Subject: Cascade River Ranch

Our team has reviewed the City comments dated May 3, 2019, and offer the following responses:

Re: Response to Cascade River Ranch City Comments dated May 3, 2019

④ NORTH / SOUTH
3/16" = 1'-0"

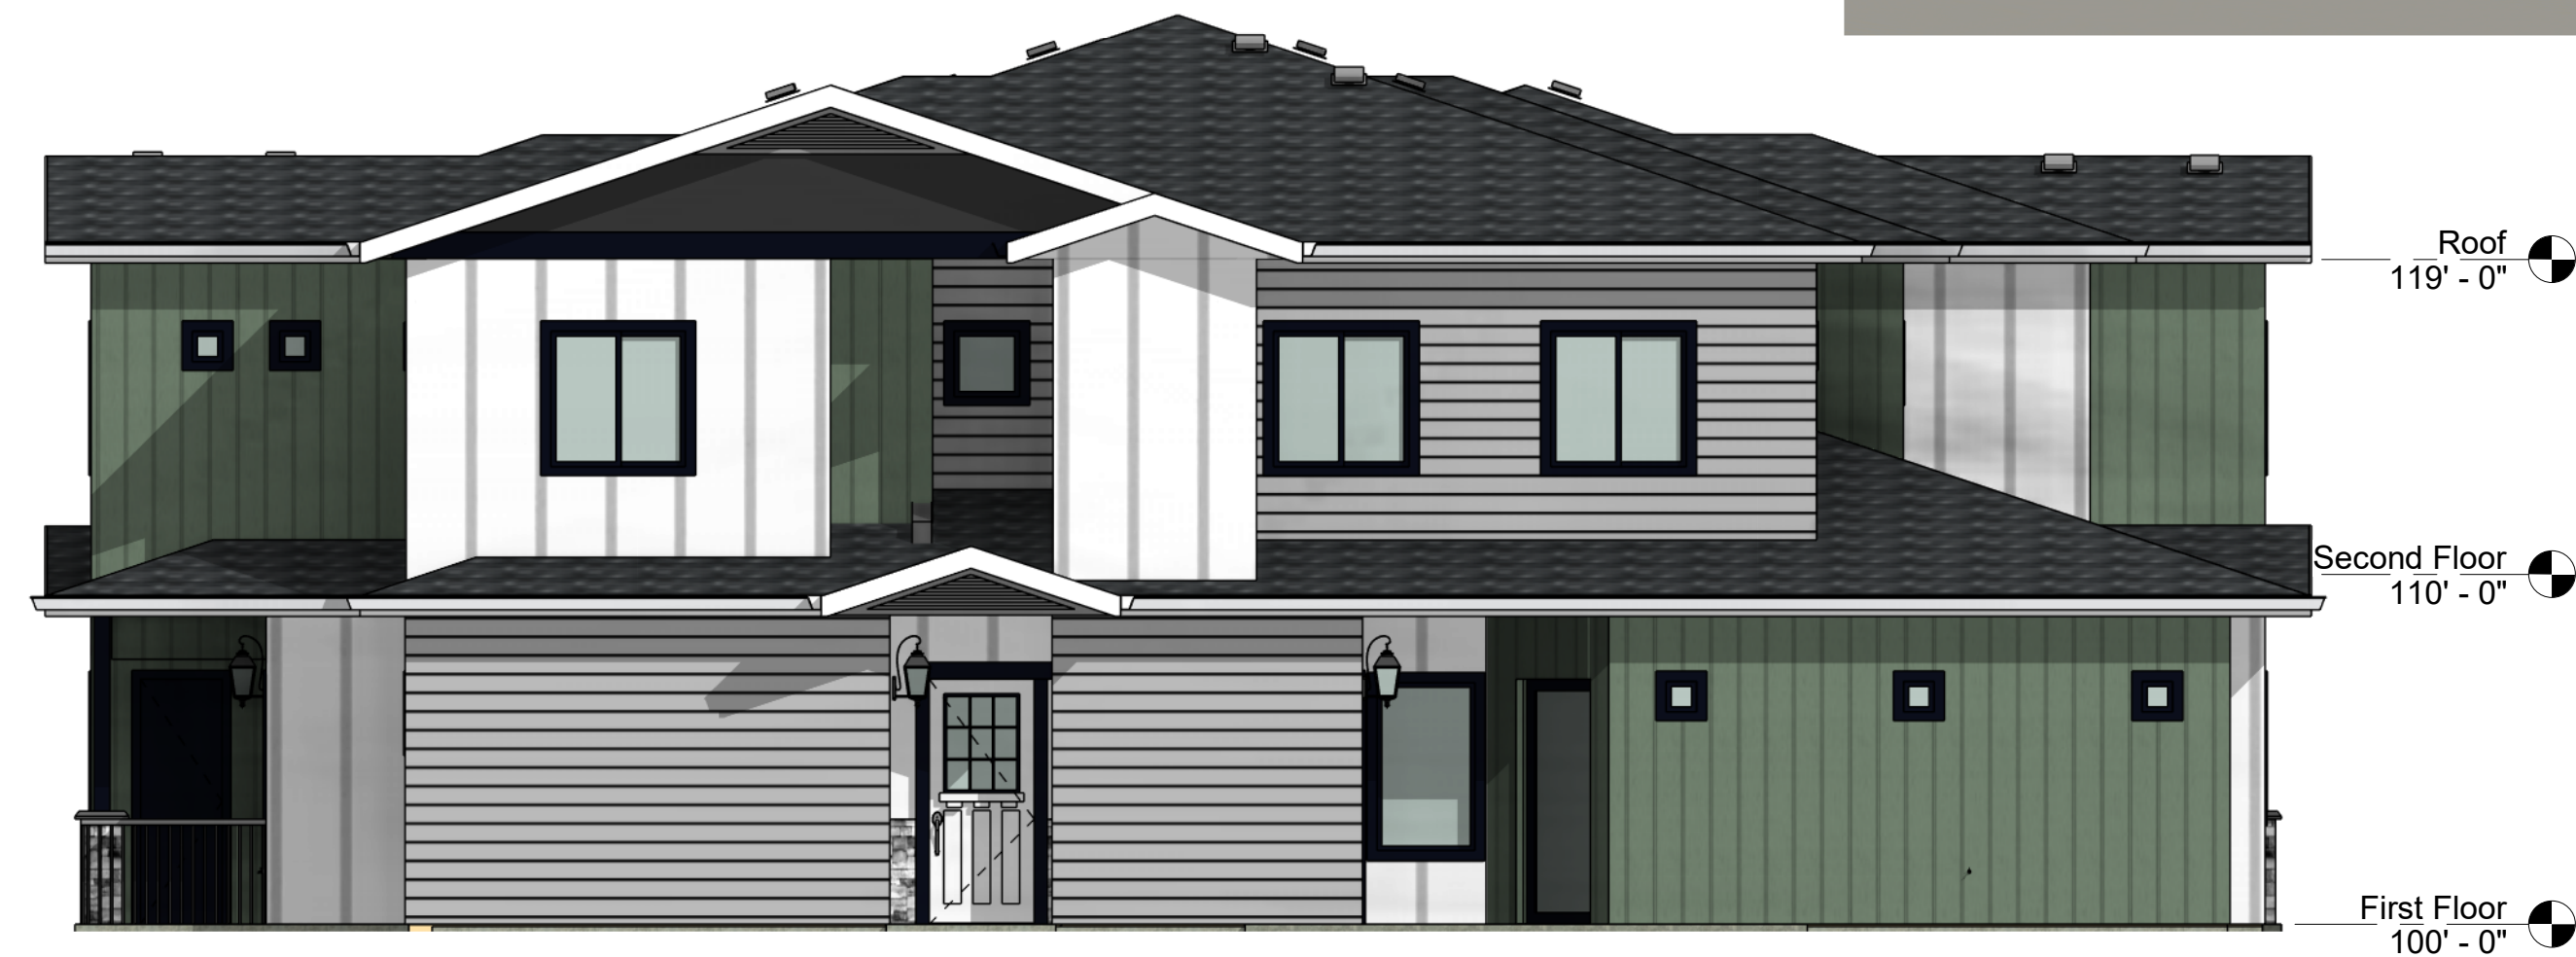
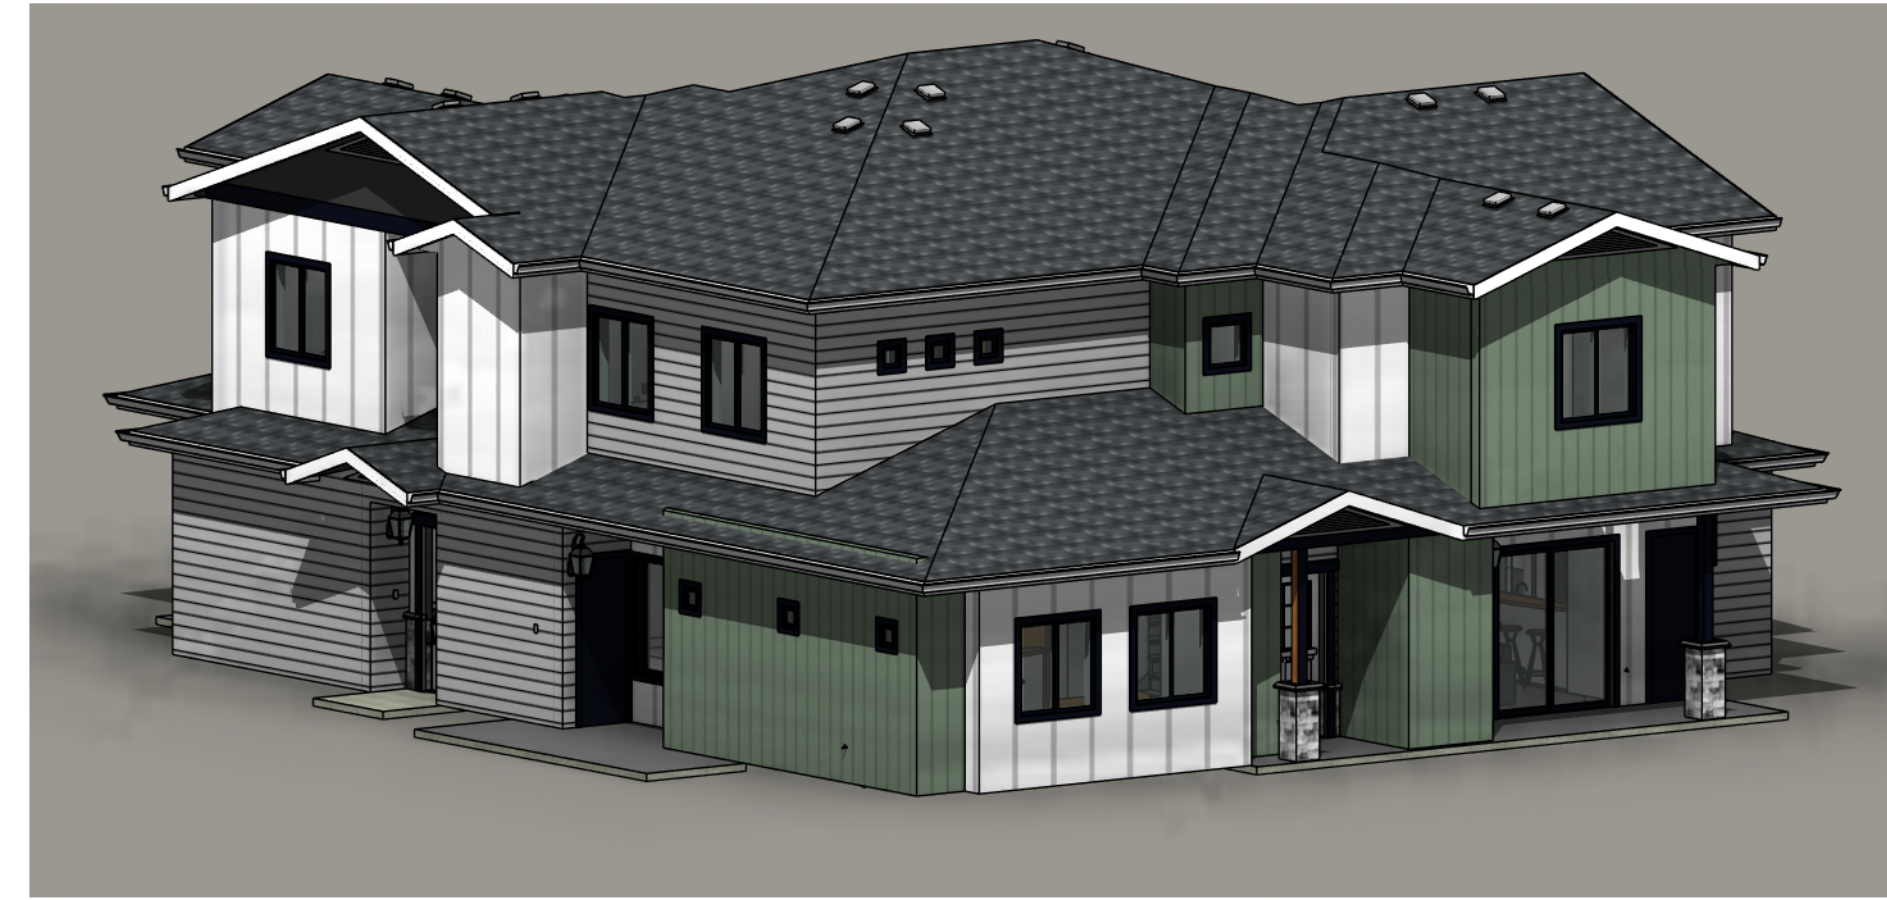
3. Provided are architectural samples as requested for the multifamily uses and commercial uses. The commercial uses will not be constructed for a long time out so we have not done a lot of work with that architectural design. A separate application could be conditioned on those commercial pads at the time those uses come into the City. A detail of the fence is on the landscape plan, and we have provided a typical detail of the trash enclosure and indicated a location on the map.

CLIENT:
Cascade River Ranch
Multifamily 24-Plex
Cascade, ID

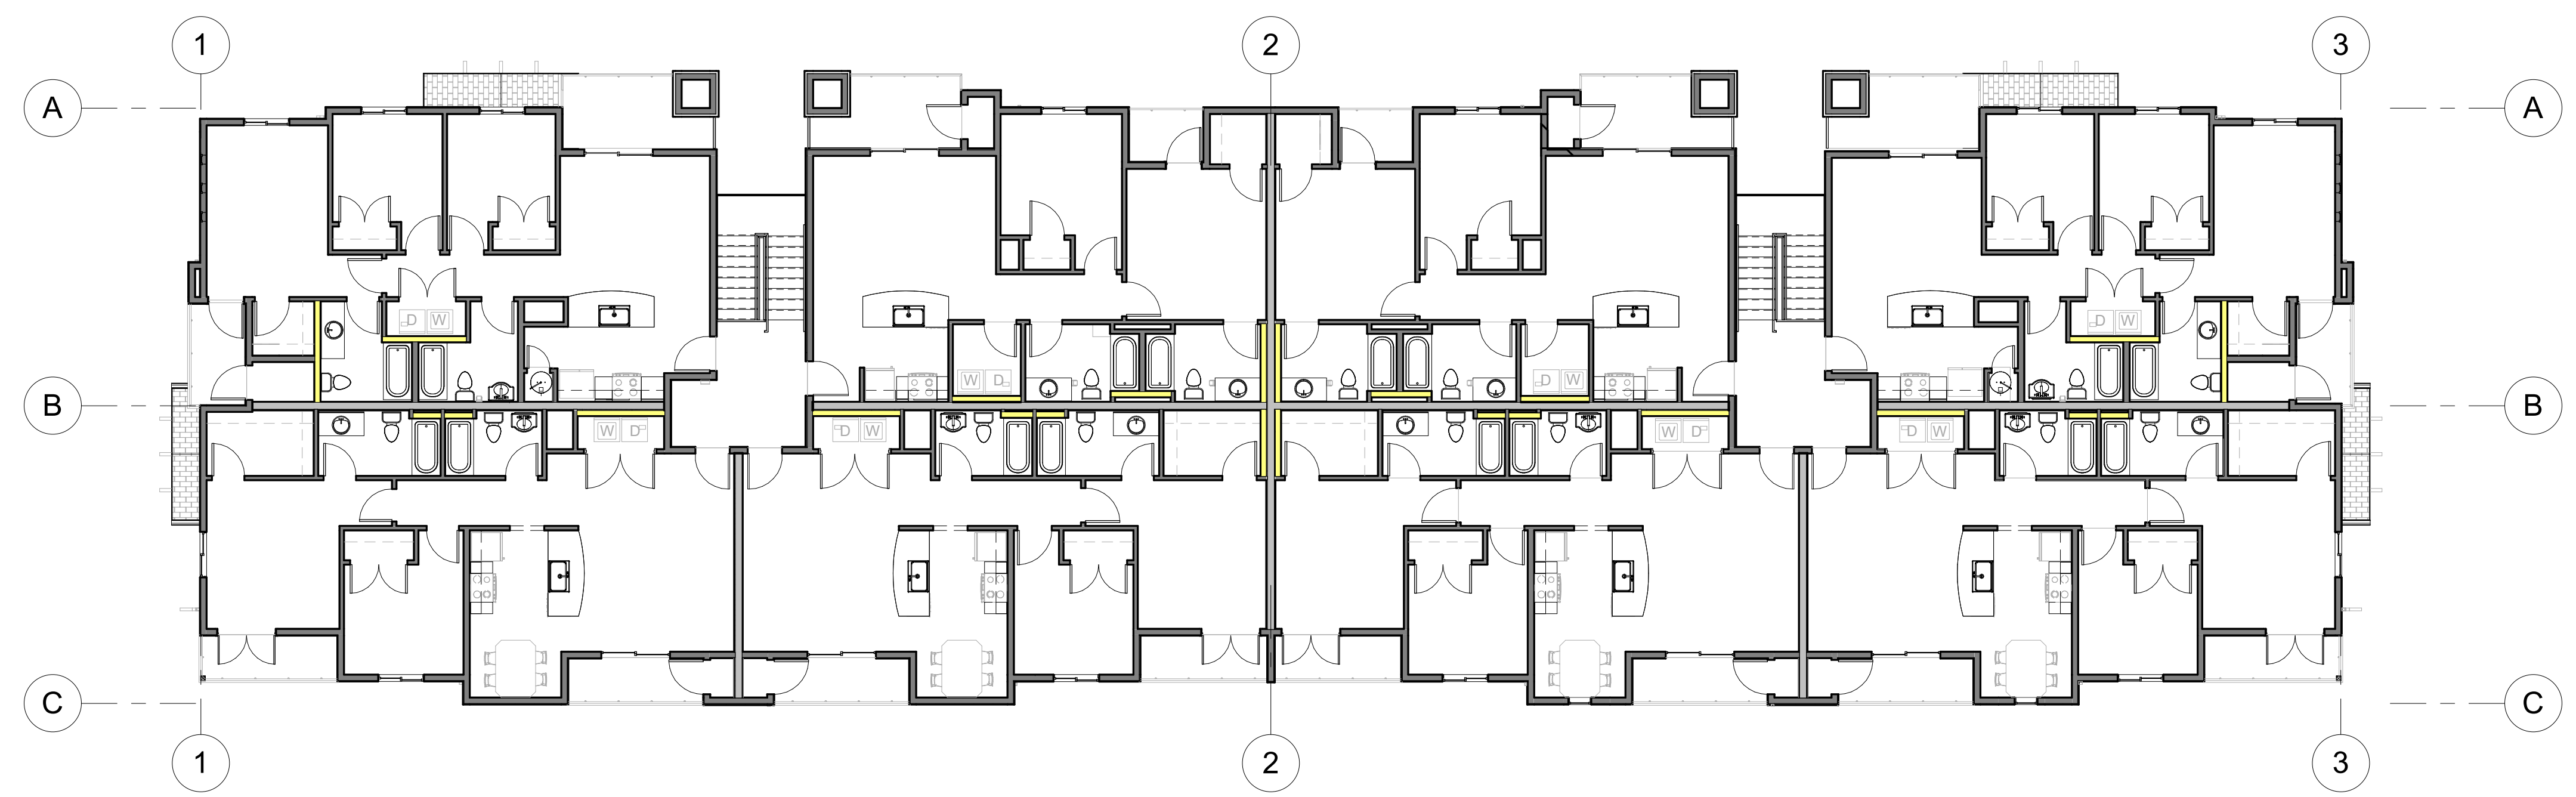
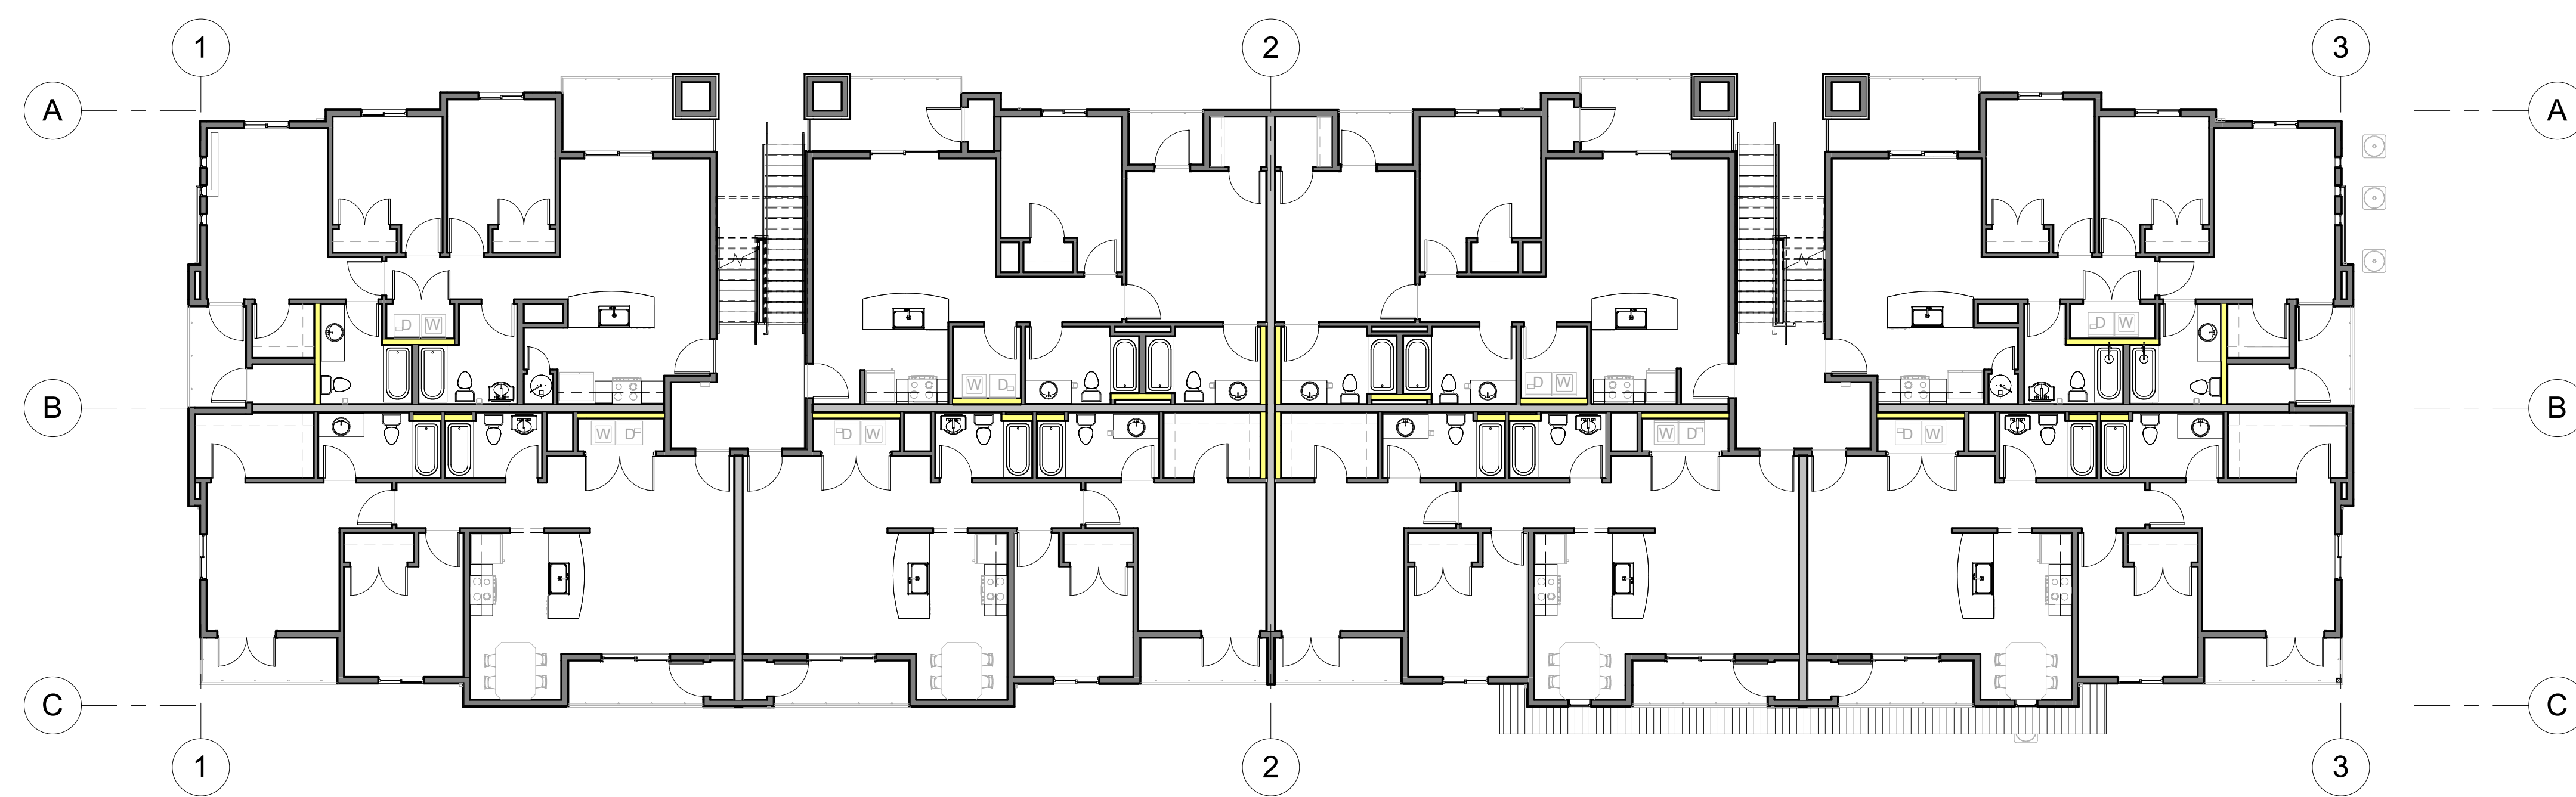
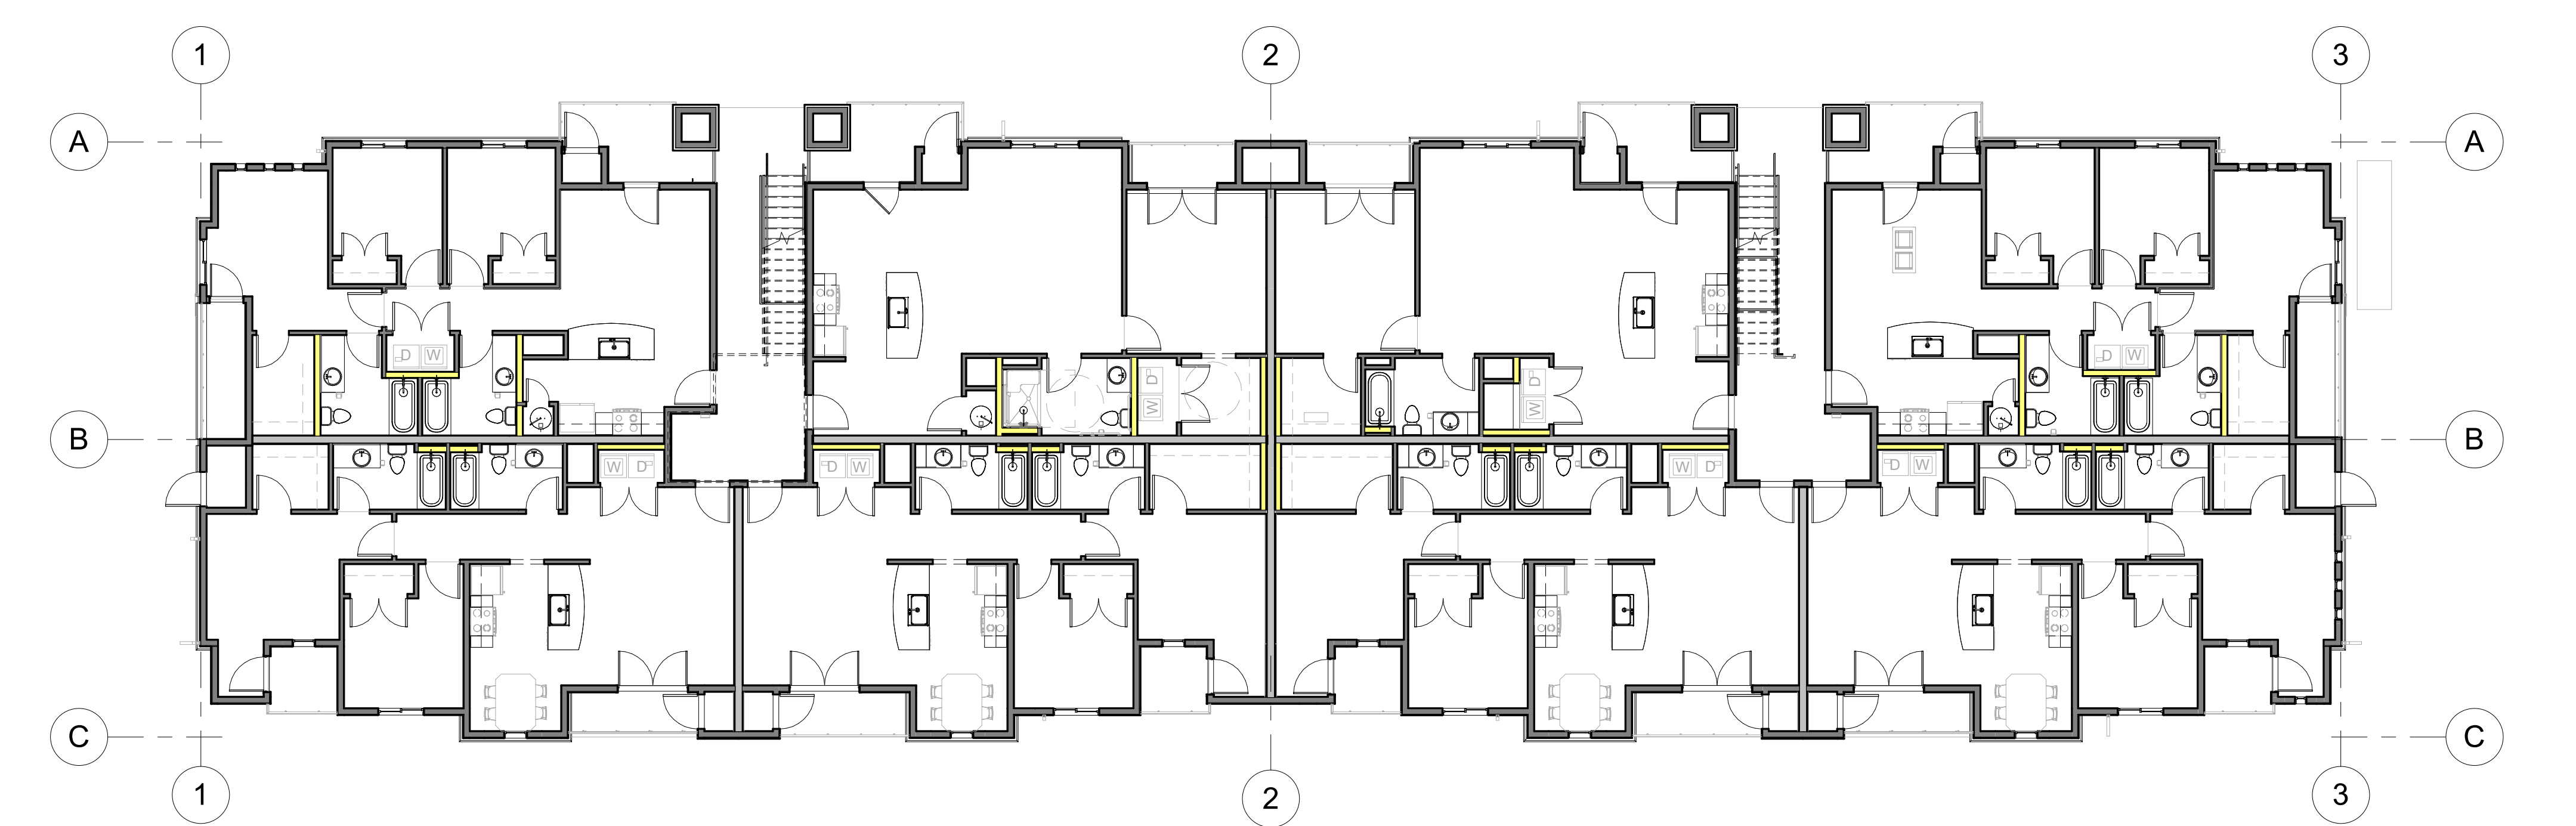
- a. I did not see a reference for an 18-plex in City Code, and we are not proposing any for this site.
 - b. I did not see a reference for a 24-plex in City Code, but we would ask for the approval of our lot size or if needed we can increase the size, but that would not really make a difference about the use.
